Minnesota Department of Natural Resources

Re: Turbine Layouts for the Getty Wind Project and Black Oak Wind Project in Stearns County [PUC Docket Nos. IP-6853/CN-11-471; WS-11-831; WS-10-1240]

Re: Black Oak Wind - Updated Assessment of January 17, 2012 Revised Turbine Layouts

Re: Updated Turbine Layouts dated May 17, 2012 Submitted for the Getty Wind Project

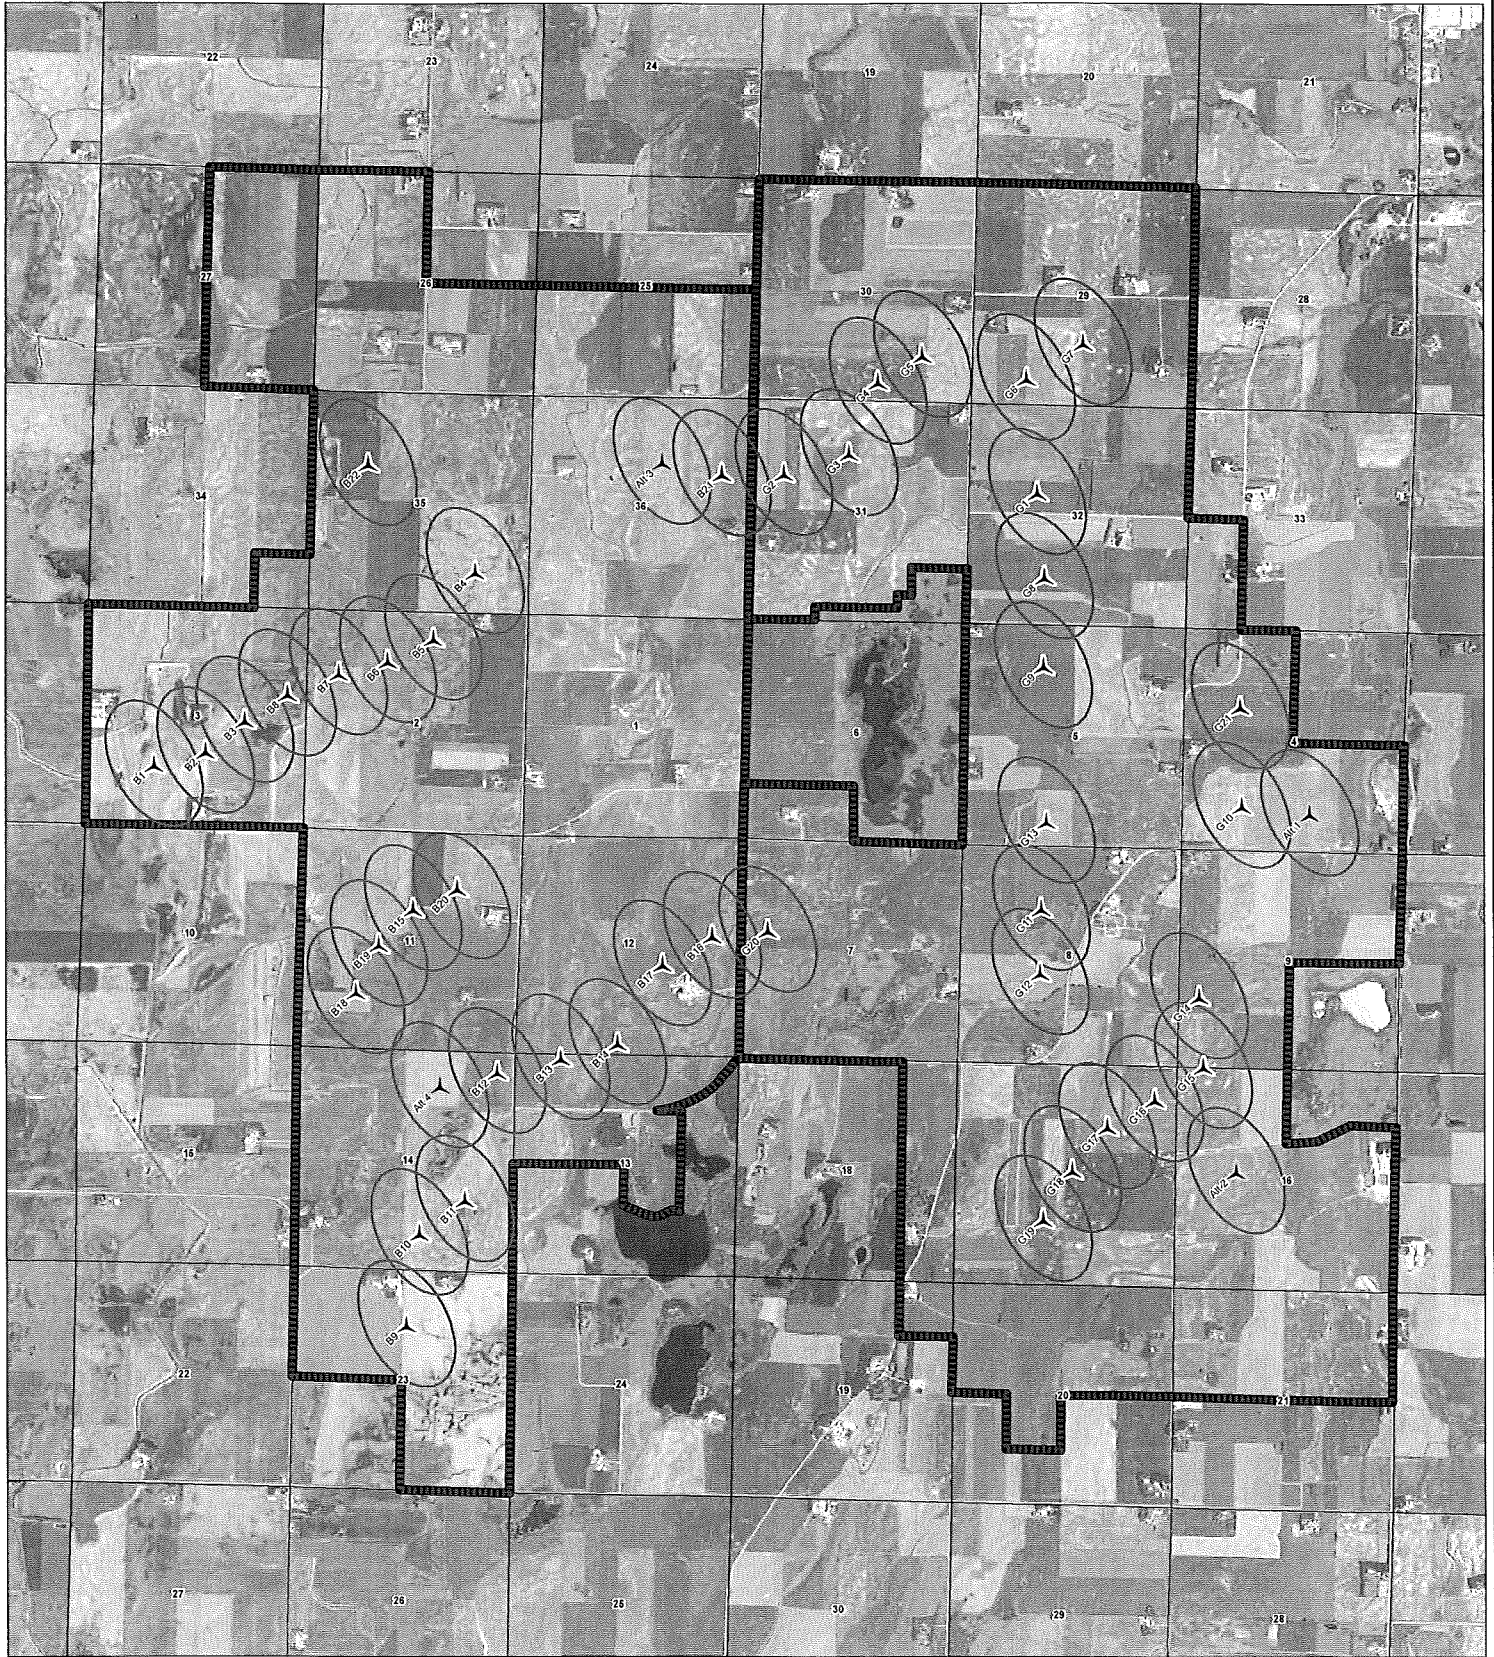
Updated turbine layouts for the Getty and Black Oak Wind Projects include the addition of Alternate turbine locations. Getty Wind Alternate turbine locations 1 (MM100 layout) and 4 (V112 layout) are placed in closer proximity than other turbines to a public water along the eastern boundary of the project area. Black Oak Wind Alternate 4 (MM100 layout), along with other turbines, is also sited in close proximity to a public water in the northeastern quarter of Section 14. The DNR assesses overall turbine siting and continues to estimate the risk level to birds and bats to be moderate for these projects due to other efforts to avoid wildlife habitat and public conservation lands in other locations across the sites. Comments in this letter and the enclosed letters should be considered to further improve project siting. The DNR would continue to recommend fatality monitoring using wildlife survey protocols appropriate for a moderate risk site as referenced previously if turbine locations to not move substantially.
